South Texas Project
Units 1 & 2
Docket Nos. STN 50-498, STN 50-499
Supplemental Information on the Safety Injection
System Piping Deficiency

**SOUTH TEXAS PROJECT
UNITS 1 & 2**

**SAFETY INJECTION
SYSTEM SUCTION LINE
ALTERNATIVE DESIGN**

Figure 1

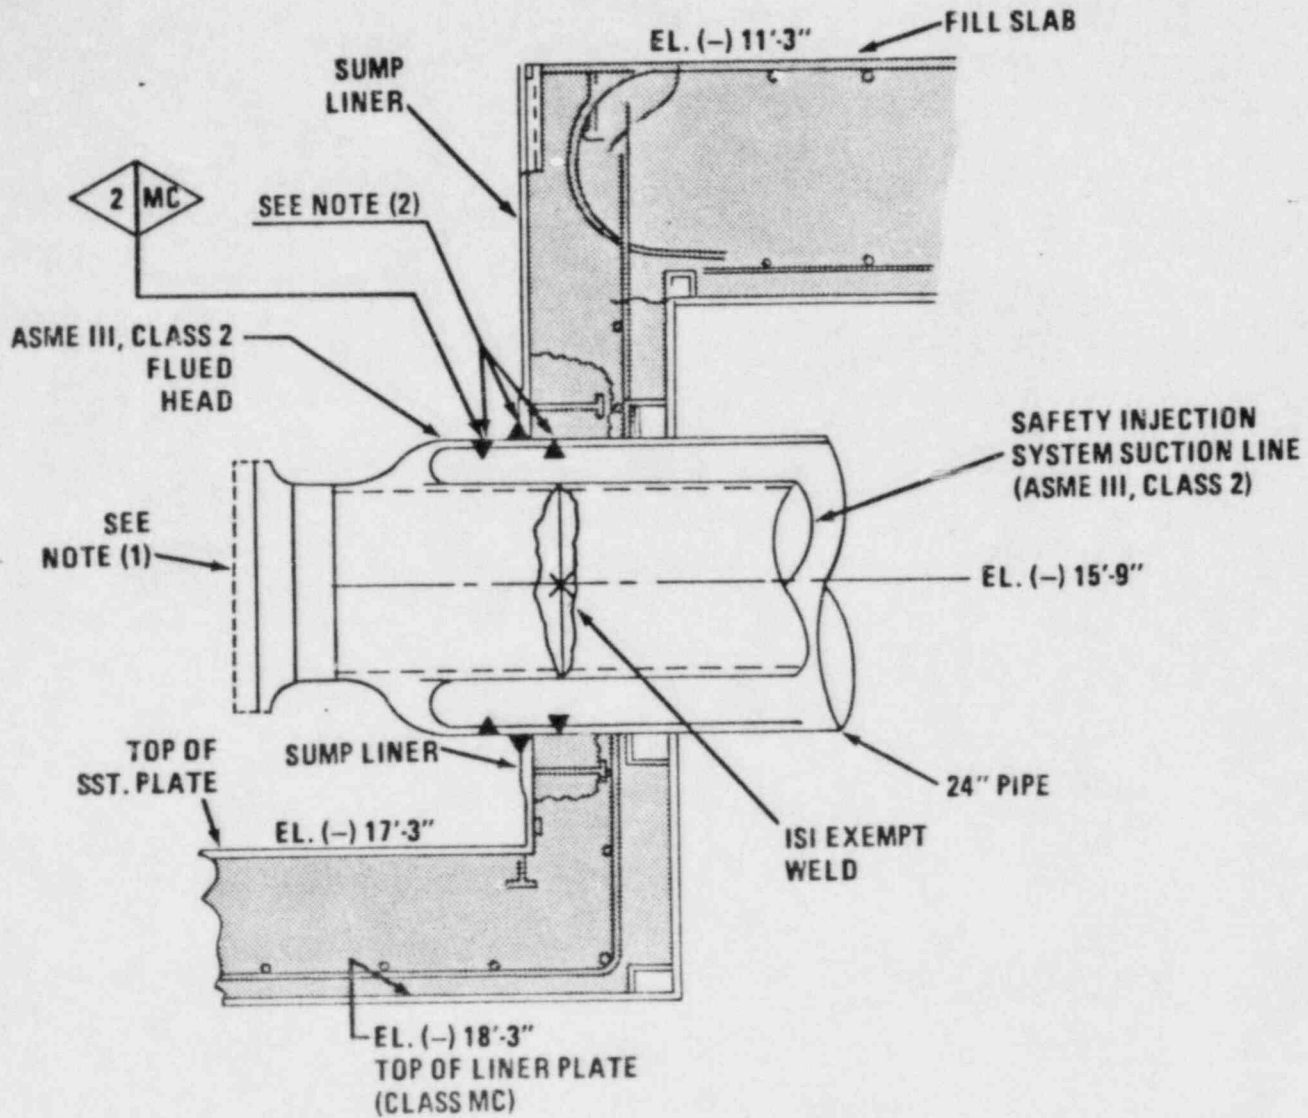
Bechtel has finished their evaluation and has modified the design. Figure 1 shows the revised design which will be used on the South Texas Project (STP). This revised design has been incorporated on the STP.

Instead of an expansion joint inside containment, the revised design features a flued head inside containment and eliminates the guard pipe, and anchor outside containment. Figure 2 shows a comparison of the previous designs with the current design.
